Access Compliance Report

Public Rights-of-Way

Intersection ID: 4850	Main Street: HARRINGTON_WOODS_RD	Cross Street: W_W_T_HARRIS_BV	Location: W
ADA ID: 6CF863D72CC4	Ramp Type: Perp	Initial Pass/Fail: Fail	Overall Compliance: No
Severity Score: 26.25			
Codes/Mitigation Info/Possible Solution		Field Measurements/Component Compliance

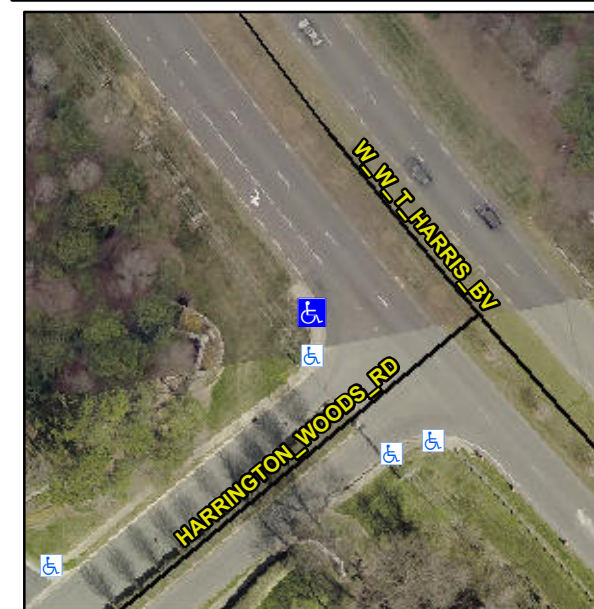
Remove & Replace Entire Ramp.

R304.2.2, R304.5.3

Compliance	Description	Data	Compliance	Description	Data
N/A	Ramp Length (in)	59.5	No	Ramp Slope (%)	20.0
Yes	Ramp Width (in)	48.0	No	Ramp XSlope (%)	4.7
N/A	Flare Type LT	N/A	N/A	Flare Type RT	N/A
N/A	Flare Slope LT (%)	N/A	N/A	Flare Slope RT (%)	N/A
N/A	Flare Traversable LT?	N/A	N/A	Flare Traversable RT?	N/A
N/A	Landing Length (in)	N/A	N/A	DWS Provided?	N/A
N/A	Landing Width (in)	N/A	N/A	DWS Contrast?	N/A
N/A	Landing Slope (%)	N/A	N/A	DWS Length (in)	N/A
N/A	Landing X Slope (%)	N/A	N/A	DWS Full Width?	N/A
N/A	Landing Curb? (Y/N)	N/A	N/A	DWS Offset (in)	N/A
N/A	Shared Landing?	N/A			
N/A	Gutter Ponding?	N/A	N/A	Gutter Slope (%)	N/A
N/A	Gutter Lip Ht (in)	N/A	N/A	Gutter X Slope (%)	N/A
N/A	Painted X Walk1?	No	N/A	Painted X Walk2?	N/A
	X Walk 1 Direction	To E		X Walk 2 Direction	N/A
N/A	X Walk 1 Width (in)	N/A	N/A	X Walk 2 Width (in)	N/A
	X Walk 1 Slope (%)	1.0		X Walk 2 Slope (%)	N/A
	X Walk 1 X Slope (%)	3.9		X Walk 2 X Slope (%)	N/A
